QUALITY ASSURANCE -- NON-CONFORMANCE REPORT

Report No: NCR-000297

Reference Description: Cracked Tack Welds, Segment 8BE

Job Name: SAS Superstructure

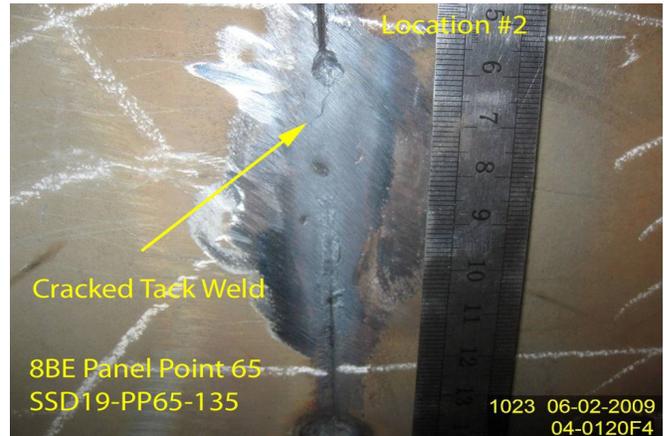
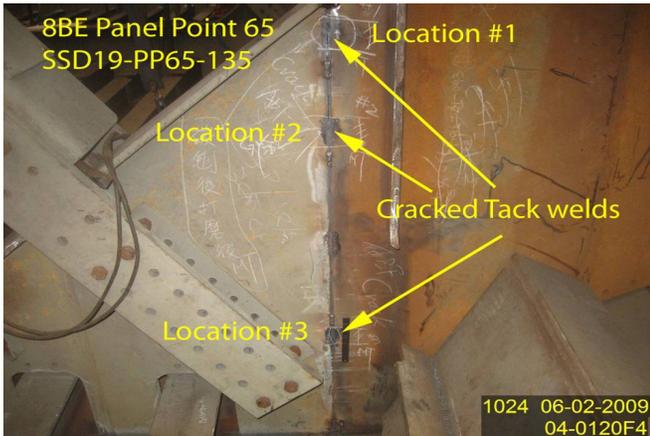
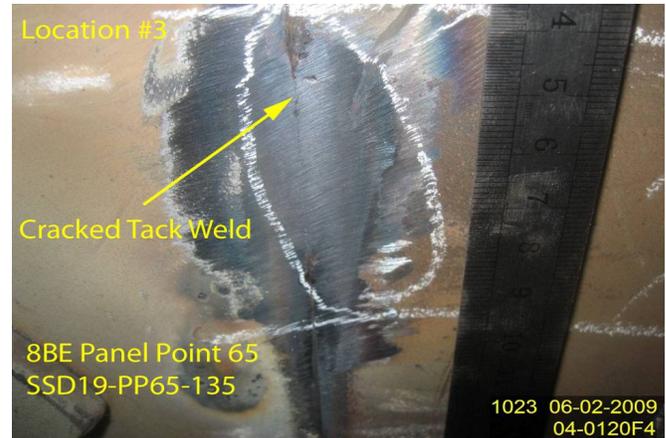
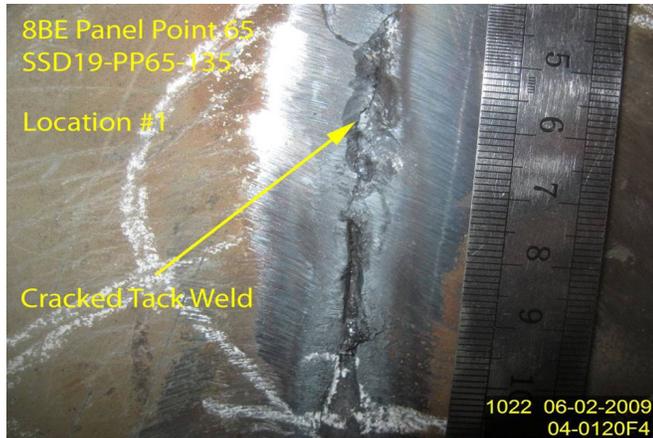
Caltrans Quality Assurance (QA) Inspector observed ZPMC welder Cao Tao (#066163) welding root pass over 3 cracked tack welds on a complete joint penetration (CJP) single bevel groove weld. Tack welds were partially ground and were being incorporated into the final weld. The welder was using the flux cored arc welding (FCAW) process in the 3G (vertical) position on weld joint SSD19-PP65-135 (Segment 8BE, Panel Point 65, FB13A).

AWS D1.5, 2002 Section 3.3.71- "Tack welds shall be subject to the same quality requirements as the final welds."

AWS D1.5, 2002 Section 6.26.1.1- "The weld shall have no cracks."

Reference Resolution: ZPMC recognizes that welding over cracked tack welds is not acceptable. As this weld is a CJP, ZPMC will perform UT to verify a sound weld.

ZPMC recognizes that welding over cracked tack welds is not acceptable. ZPMC has notified the welder and onsite CWI of this nonconformance. As this weld is a CJP, ZPMC will perform UT to verify a sound weld. Reports will be forwarded at a later date.

Reference Description: Cracked Tack Welds, Segment 8BE

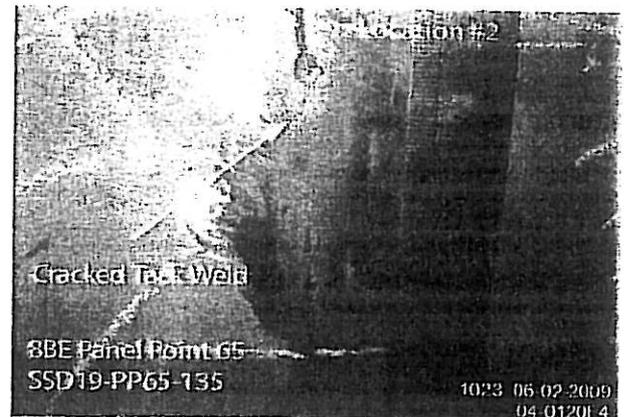
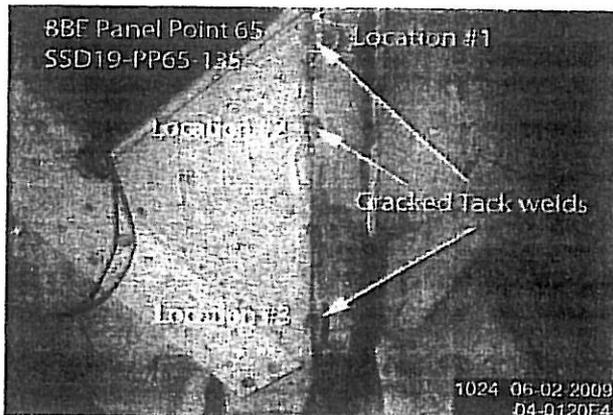
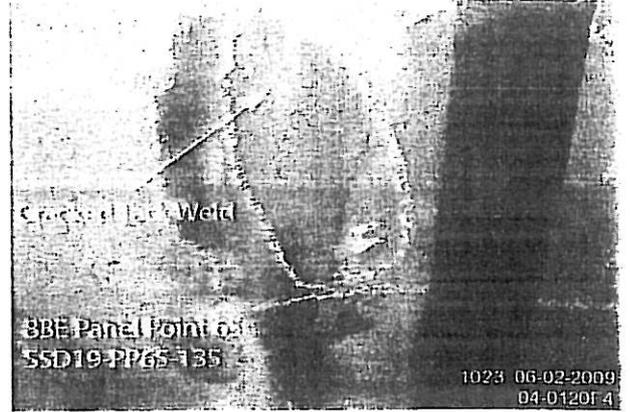
Caltrans Quality Assurance (QA) Inspector observed ZPMC welder Cao Tao (#066163) welding root pass over 3 cracked tack welds on a complete joint penetration (CJP) single bevel groove weld. Tack welds were partially ground and were being incorporated into the final weld. The welder was using the flux cored arc welding (FCAW) process in the 3G (vertical) position on weld joint SSD19-PP65-135 (Segment 8BE, Panel Point 65, FB13A).

AWS D1.5, 2002 Section 3.3.71- "Tack welds shall be subject to the same quality requirements as the final welds."

AWS D1.5, 2002 Section 6.26.1.1- "The weld shall have no cracks."

Reference Resolution: ZPMC recognizes that welding over cracked tack welds is not acceptable. As this weld is a CJP, ZPMC will perform UT to verify a sound weld.

ZPMC recognizes that welding over cracked tack welds is not acceptable. ZPMC has notified the welder and onsite CWI of this nonconformance. As this weld is a CJP, ZPMC will perform UT to verify a sound weld. Reports will be forwarded at a later date.

WELD NUMBER: SSD19-PP65-135

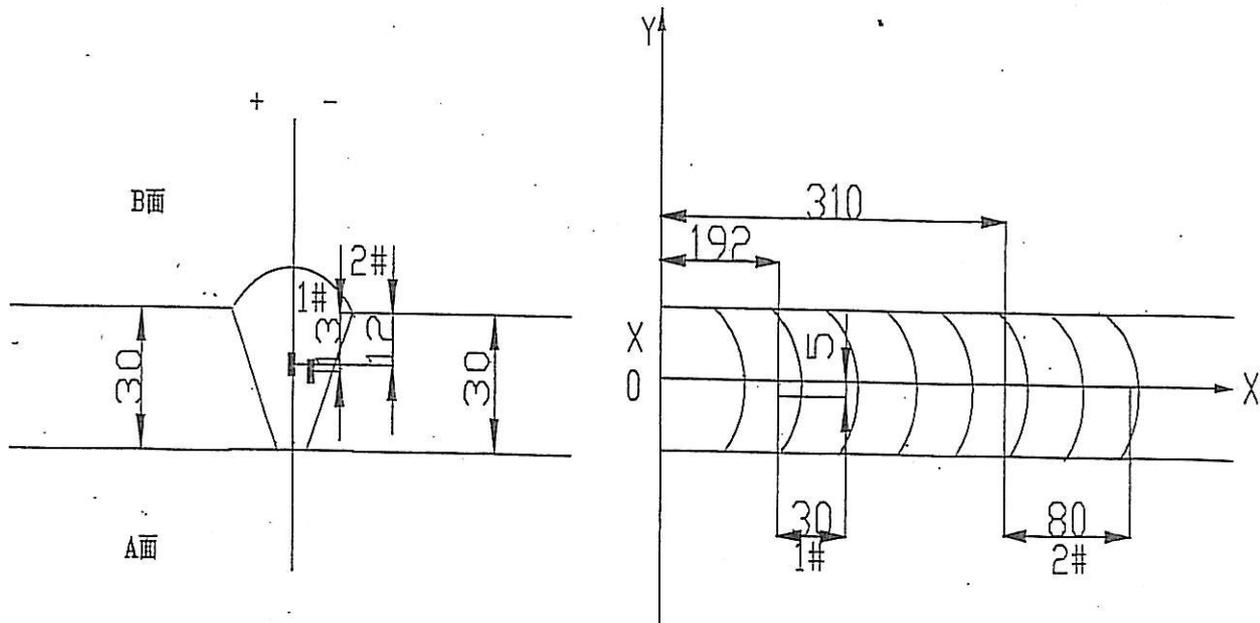
Rejected indication found by ultrasonic inspection is less than the maximum allowance, aggregate length.

(UT探伤发现的缺陷总长度小于最大允许长度。) SSD19-PP65-135

1. Gouge or grind from nearer side from metal edge ($D \leq 0.65T$, "D" is depth of defects, "T" is thickness of metal) to remove all defects;
2. Follow repair WPS for joint preparation, preheat, and weld deposit;
3. Verify with VT no defects remain in the weld joint prior to welding;
4. Grind the repaired area flush with base metal or the adjacent weld;
5. Check the welds according to the working drawings.
